CITY OF ALBUQUERQUE

RE: ANCALA VILLAGE TOWNHOMES (F-21/D76)
Engineers Certification for Release of Financial Guaranty
Approved Engineers Stamp dated 05/20/2005
Engineers Certification dated 06/05/2006

**Re: Ancala Village Townhomes, Tract B, Unit 2, Academy Square
Grading & Drainage Plan - Engineer Stamp date 5-20-05 (F21/D76)**

**Re: Ancala Village Townhomes, Tract B, Unit 2, Academy Square
Drainage Management Plan - Engineer Stamp date 3-24-05 (F21/D76)**

Figure 6 Drainage channel / retaining wall profile

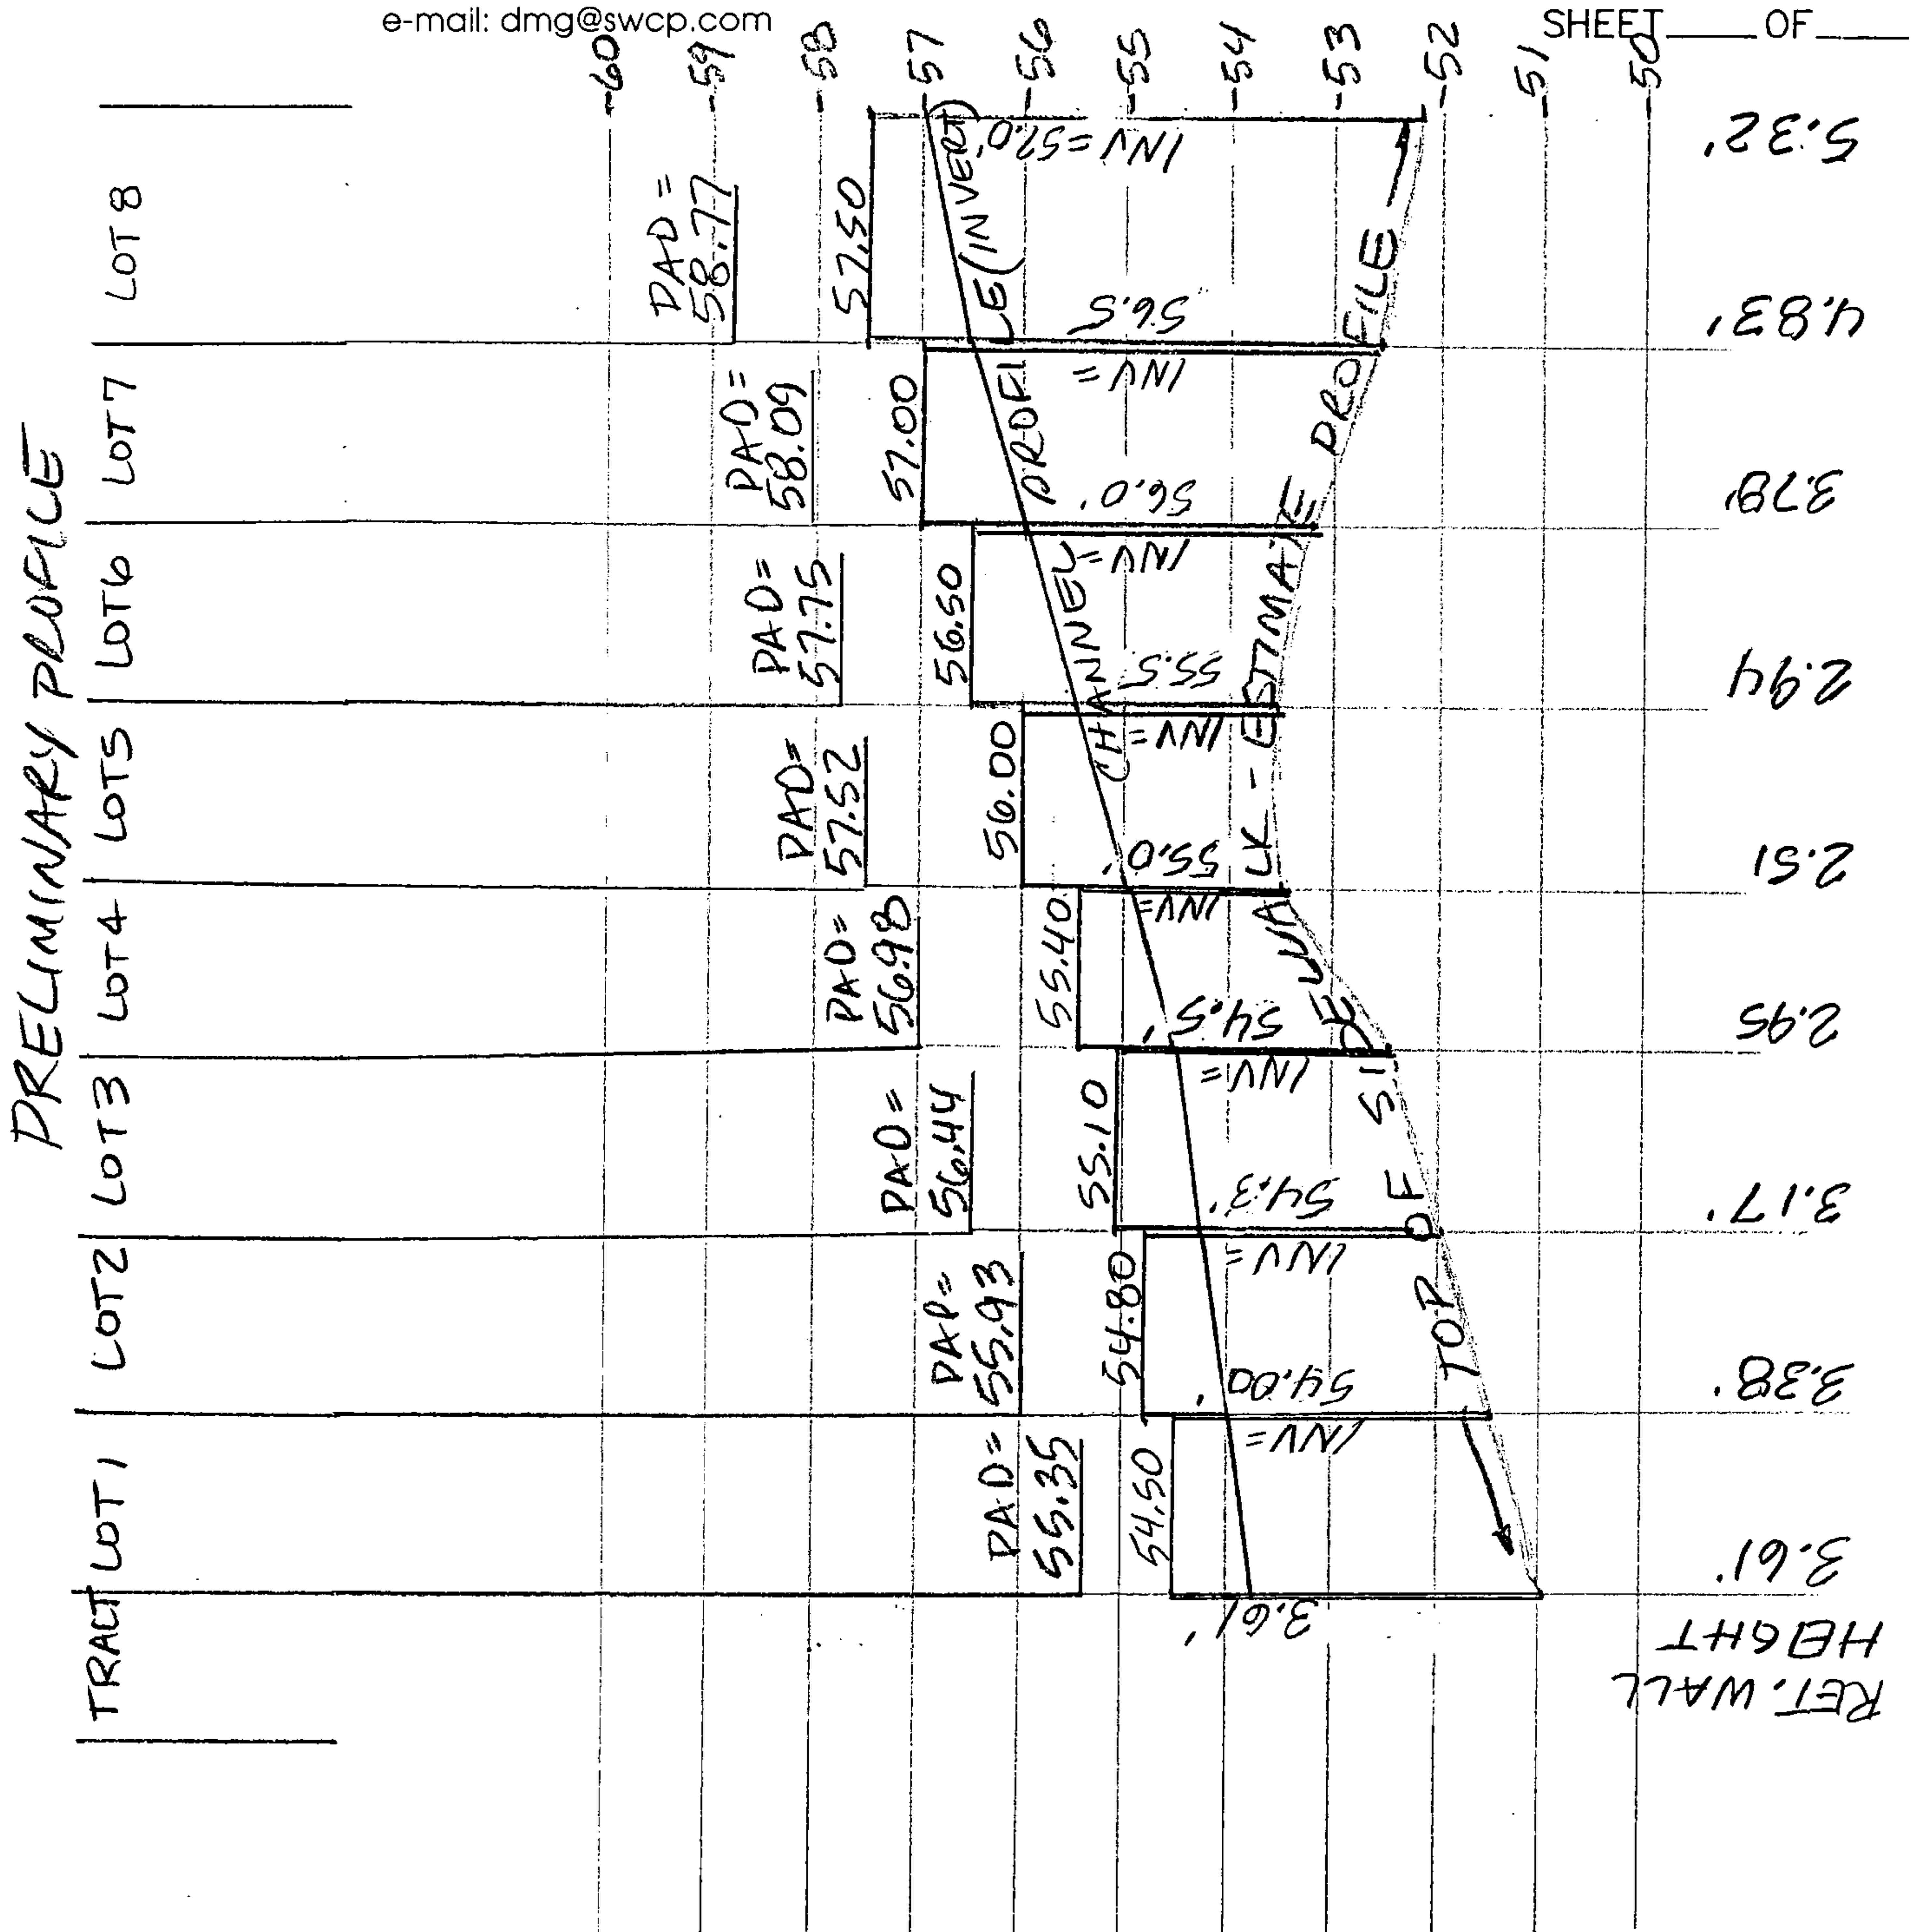
- Increase the size of the sidewalk culvert to 2'-0" and add to Infrastructure List.
- Detail backyard concrete channel so that it is independent of the garden wall.
